## Appendix 2

### RDF Background Documentation

## 1. Comparison of Lot Type 1 with Havelock North General Residential Zone Rules

### Assessment of the Residential Development Framework against the Hastings District Plan

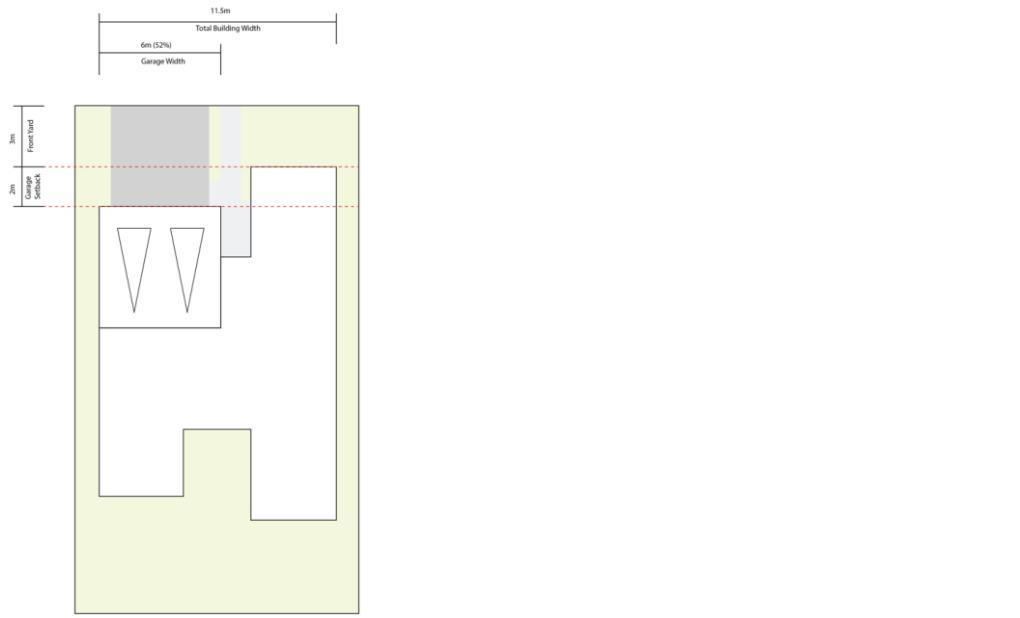
HDC Havelock North General Residential Zone		Arataki Project Lot Type 1 – Residential Development Framework	
HDP Rule	HDP Requirement	RDF Standard	Comment
		<p>setback of 2m from the rest of the building.</p> <p>Note 1: Standards b. and c. above do not apply to Lots 19, 20, 71, 72, 121, 151, 152, and 162.</p>	<p><b>Commented [AS1]: This is a complex rule - is it really necessary? A diagram may assist to explain it</b></p>

(d) Garages on sites that front a public road or JOAL and that form part of a single-storey residential building, shall occupy a maximum of 50% of the width of the front elevation of that residential building.

(e) Garages on sites that front a public road or JOAL:

- (iii) that form part of a single-storey residential building; and
- (iv) which occupy more than 50% and up to a maximum of 60% of the width of the front elevation of that residential building must have a minimum setback of 2m from the rest of the building.

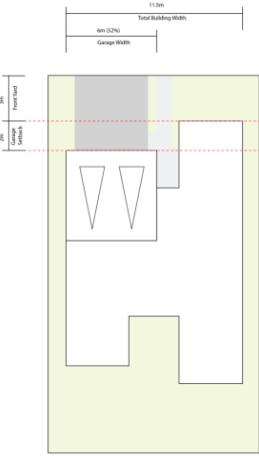
**Commented [NA1]:** Please ensure the SMP includes the flow diagram from our meeting 6/11/2025 and some clear instructions/way to determine the appropriate sized detention tanks should a design be over 60% impervious and require mitigation.

**Commented [NA2]:** The public spaces and reserves team have stated that the lot 3 side boundary should also have a 1.8m high, open style pool fence (currently shown as a corner fence) Please amend to include
